CLINTON CREEK ASBESTOS MINE

WASTE AND TAILINGS PILES
Review Report

Northern Affairs Program
Water Resources Division
Whitehorse, Y.T.

March 1986

FIGURE 3.

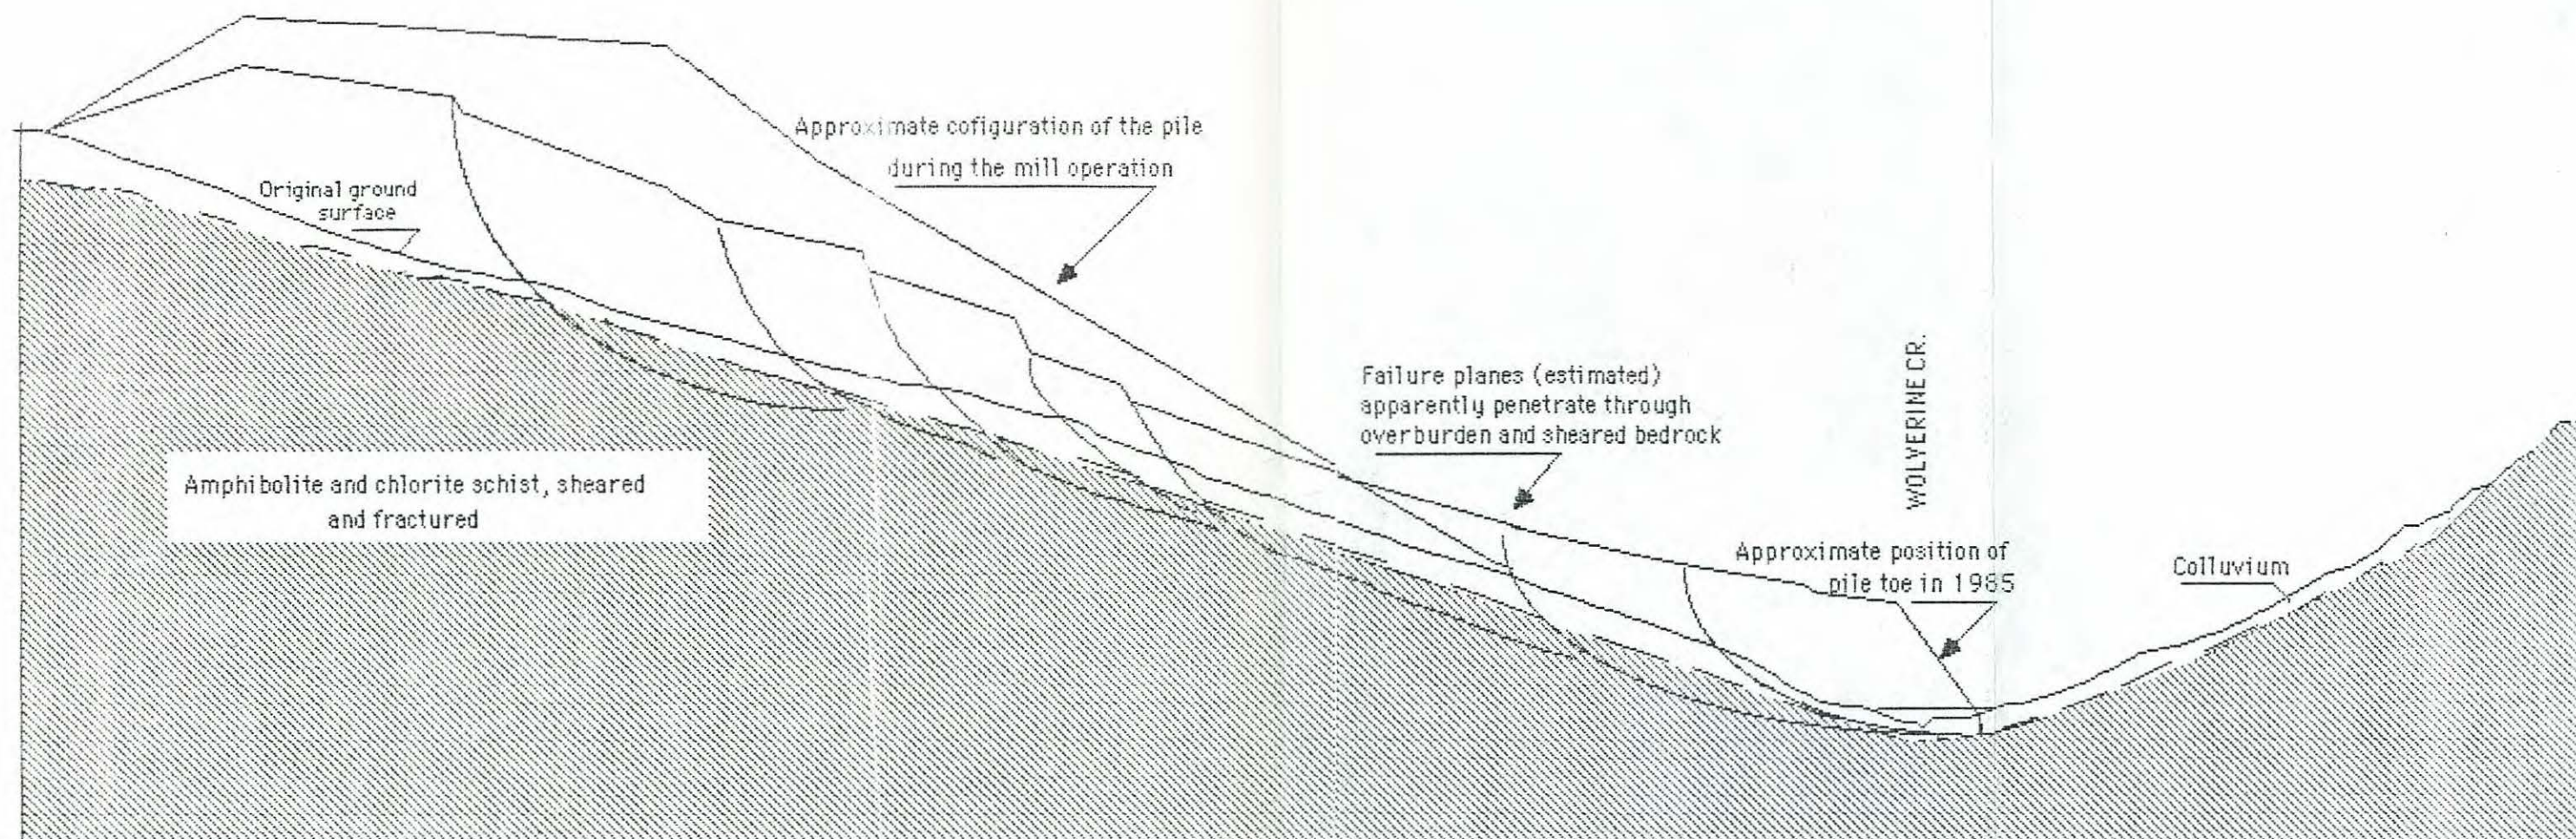
The continuing retrogressive and lateral erosion will gradually breach the crest of the valley blockage and lower the lake level. Some of the events may be more extensive, causing temporary blockages of the outfall channel. This, in turn, will temporarily increase the lake elevation and accelerate erosion. The outflow from the lake could change its pattern and erode a new gully. This, in turn, may increase the rate of sliding.

The state of equilibrium will not be achieved until the most of the current valley blockage is redeposited further downstream. The estimated total volume of waste material is in the range of $35 \times 10^6 \text{m}^3$. It is conceivable that about one third to one half of this volume will be eventually eroded away and redeposited downstream

Because the waste dump is still exhibiting horizontal movement into the channel, there is an ongoing process of toe erosion and localized slope failures which provide the stream with a high sediment load and additional bed paving material.

The estimated slope of Clinton Creek through the waste dump is 4.5 percent.

With respect to abandonment the key issues would seem to be the future stability of the channel through the waste dump and the rate at which sediment will be supplied to a point downstream of the dump. At present this system is in a state of relatively rapid change. Laterally the channel is confined by natural bedrock on the left and by waste slopes that are still exhibiting horizontal movement on the right. The rate of supply of sediment to the channel through a cycle of toe erosion and localized slope failures in the encroaching dump material is high. This process can be expected to cause localized blockages in the channel which will subsequently erode and be transported downstream. The rate of downcutting has undoubtedly decreased due to the development of a bed paving layer. With time as this paving layer thickens progressively higher flows will be required to disturb the bed paving. In the longer term, as the rate of movement of the dump decreases the channel will tend to widen and migrate laterally into the dump. Downcutting can then proceed as the paved bed will be abandoned.

There are a variety of situations that could cause the failure or abandonment of the rock-lined outfall channel. This is likely to have little impact on the quantities of sediment supplied to the channel along its entire length. Indeed, consideration should be given to allowing the lake outlet to degrade along with the downstream channel.

FIGURE 4.

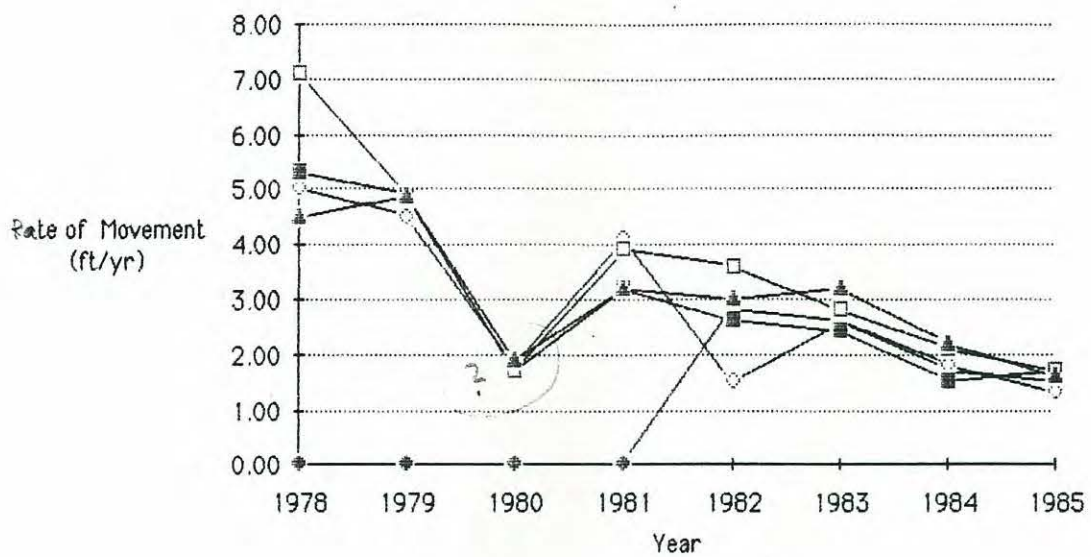
The rates of movement suggest that both tailings lobes are moving in a "caterpillar-like" manner. As a lower segment fails, toe support for the section above is removed and the failure gradually progresses up the slope. The amount of horizontal movement decreases in the upslope direction. The toe of the dump is rising and gradually spreading in the valley bottom.

Progressive failure of the north tailings pile lobe (moving presently in the order of 25 m/yr) will likely spread the tailings material across the entire valley bottom. The slide will form a new lake which could be larger than the existing one.

The blockage would be eventually overflowed, forming a new outfall channel likely outside the present rock-lined spillway. The tailings would be eroded progressively down resulting in lowering of the lake level, flooding of the downstream valley section and transportation as well as deposition of large quantities of fine to coarse tailings particles throughout the Wolverine and Clinton Creek valleys. Again, this event may re-occur several times until an equilibrium between the erosion rate and the tailings pile movement is achieved.

It is possible that more than one half of the pile volume which comprises about 10 to 12 x 10⁶ tones (about 6 x 10⁶m³) of tailings will be eventually displaced.

The main issues of concern with regard to abandonment are uncertainties about conditions that will develop when the north lobe blocks the valley and causes the present impoundment of water to be displaced upstream, and whether or not it will be practically feasible to maintain flow in the rock-lined channel.

In practical terms it may not be feasible to maintain Wolverine Creek flows in a rock-lined crossing of the tailings dump. At a minimum, significant ongoing maintenance costs can be anticipated. Already concerns have been expressed that the capacity of the upper section of the channel has decreased due to encroachment of tailings into the channel. If the rate of encroachment is greater than the capacity of flow in this channel to erode and transport sediment to the steeper section then infilling will ultimately cause the rock-lined channel to be bypassed. When this happens a new channel will rapidly downcut in the highly erodible tailings. Abandonment of the rock-lined channel is also a possibility if not a likelihood when valley blockage by the north lobe occurs and the lake outlet is displaced upstream.

Consideration should be given to the alternative of allowing the rock-lined channel to be bypassed. If this were to occur a new channel would downcut quite rapidly and develop a graded profile through the dump that would be in rough equilibrium with the rate at which sediment is supplied to the channel. The sediment supply rate would in turn depend on the rate of encroachment by the tailings slope confining the right bank of the channel. A repeating cycle of encroachment, toe erosion, localized slope failure and transport of slumped material downstream could be expected. Periodical channel blockages could occur due to local slumping. These would be accompanied by ponding, overtopping and rapid downcutting of the slump material. Delivery of sediment downstream would be consistent with the capacity of the high gradient channel to erode and transport the tailings.

FIGURE 5.

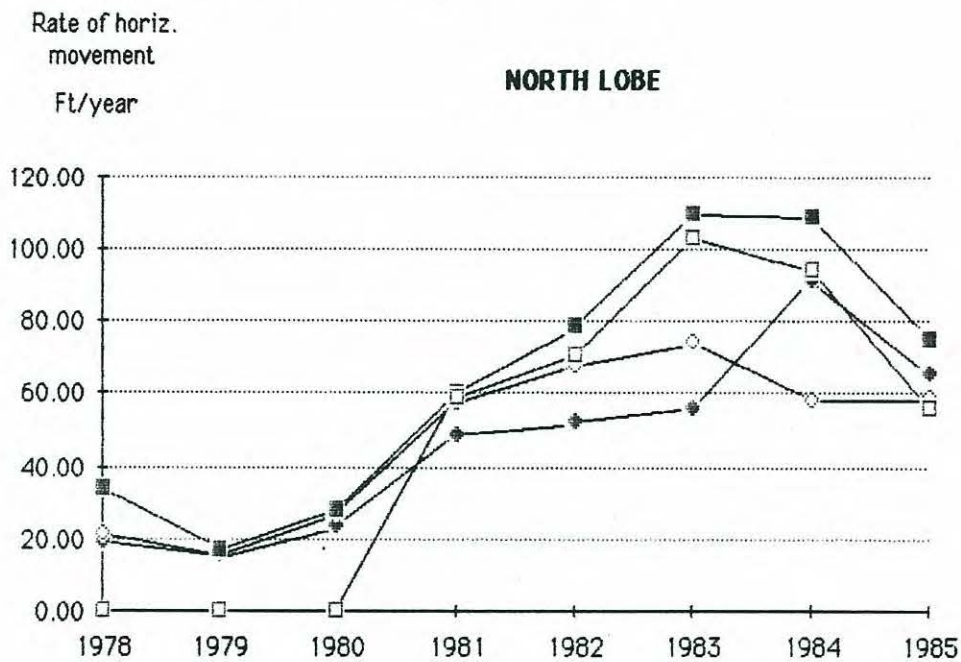
Ranges of horizontal movement (not seasonally adjusted), measured during the 1984-1985 monitoring period, are listed below:

Clinton Creek Waste Dump	0.4 - 0.6 m/yr
Clinton Creek Channel Bank	0.3 - 0.5 m/yr
Wolverine Creek North Lobe	0.1 - 10.4 m/yr
Wolverine Creek South Lobe	17.1 - 22.9 m/yr

Typically, the horizontal rate of movement is about 1.25 times greater during the summer season than in the winter.

Horizontal movements for the toe areas of the waste dump and tailings pile are plotted on diagrams shown on Figures 5 and 6.
